## Water Leaks — Cowl Top To Side Panel Joints

### 1965-66 Mustangs

Information for "The Troubleshooter" is taken from Ford Motor Company Technical Service Bulletins issued to dealer service departments

Illus. S1068-A — Water Leaks - Cowl Top to Cowl Side — 1965-66 Mustang and  
1966 Falcon, Fairlane — All Models — (Article 841)

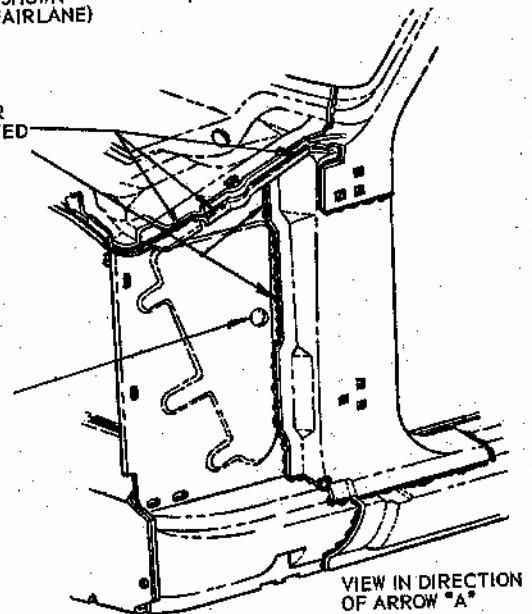
To eliminate water leaks in this area on the 1966 Mustang, effective February 18, 1966, the length of the braze has been extended an additional  $\frac{3}{4}$ " in the area where sealer application is difficult, followed by complete application of sealer over the braze and the cowl top to cowl side panel weld flange.

Dealers encountering customer complaints relative to water leaks in this area should add liquid butyl (Part Number C5AZ-19554-A) or caulking cord (Part Number AB-19560-A) to the affected areas as outlined in the following procedure and accompanying sketches.

1. To gain access to the cowl top and cowl side panel weld flanges, remove the front wheel and splash shield. The splash shield is retained with five screws.
2. Apply liquid butyl or caulking cord along the flange areas sufficiently to seal any open seams. See illustration.
3. Check the plug buttons in this area and seat them if necessary. Cover the edges with liquid butyl to seal.
4. Water test vehicle to assure adequate sealer application.
5. Reinstall the splash shield and wheel.

APPLY LIQUID BUTYL (C5AZ-19554-A) OR  
CAULKING CORD (AB-19560-A) TO AFFECTED  
AREA

SEAT THE RUBBER PLUGS IF  
THEY ARE NOT SEATED AND APPLY  
LIQUID BUTYL (C5AZ-19554-A)
